ELECTRICAL ADDENDUM #1
Terra Nova National Park
New Kitchen Shelter, Newman Sound
Issued May 28, 2018

NEW KITCHEN SHELTER
NEWMAN SOUND

REVISED TRENCH DETAIL
AND PARTIAL ELECTRICAL
DISTRIBUTION SYSTEM

project no.: PCA NO. 457
dwg no.: ESK-1

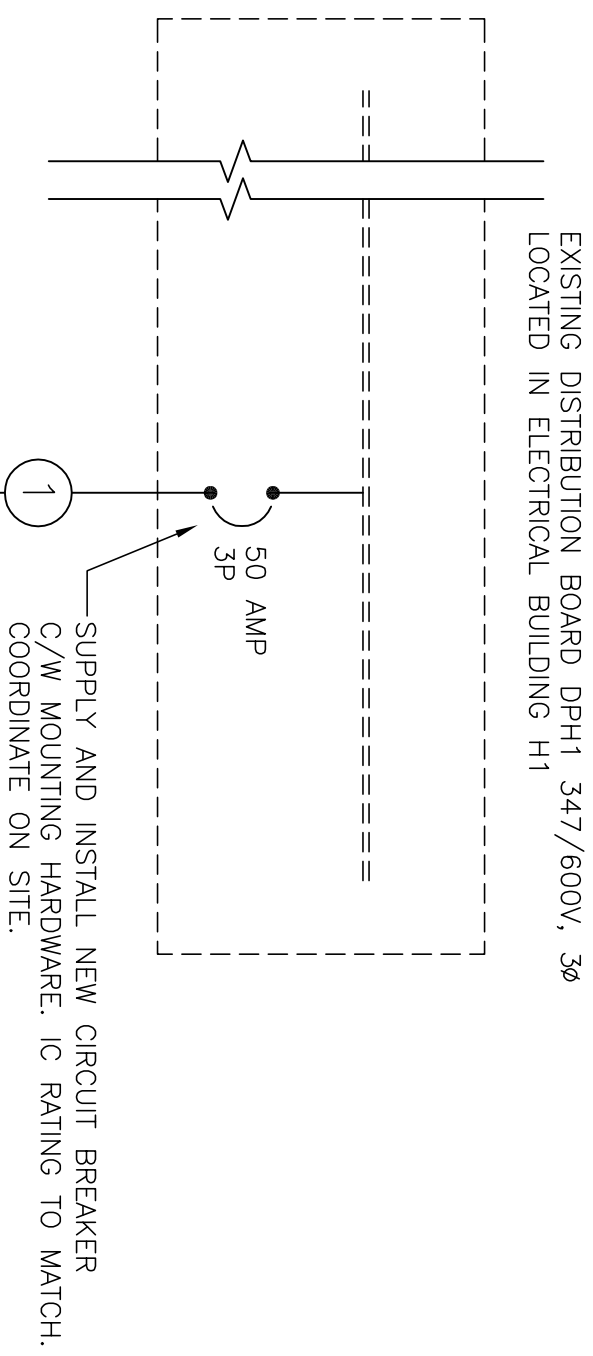
1. Reference partial electrical distribution system - single line diagram and trench detail. See sketch ESK-1 for revised partial electrical distribution system - single line diagram and trench detail.
2. Reference panel schedule for K1. Service entrance rated main breaker for Panel K1 shall be rated 125 Amps, 3 pole, c/w mounting hardware, IC rating to match. Coordinate on site. Delete reference to 100 Amp 3 pole main breaker.

BROKEN LINE INDICATES EXISTING.
SOLID LINE INDICATES NEW.

SYMBOL	WIRE AND CONDUIT SIZE
①	3 #6 RW90 + 1 #8 TW GROUND IN 27mm EMT CONDUIT
②	4 #2/0 TECK + GROUND
③	1 #6 TW GROUND IN 21mm EMT CONDUIT. CONNECT TO EXISTING GROUNDING BUS. COORDINATE ON SITE.
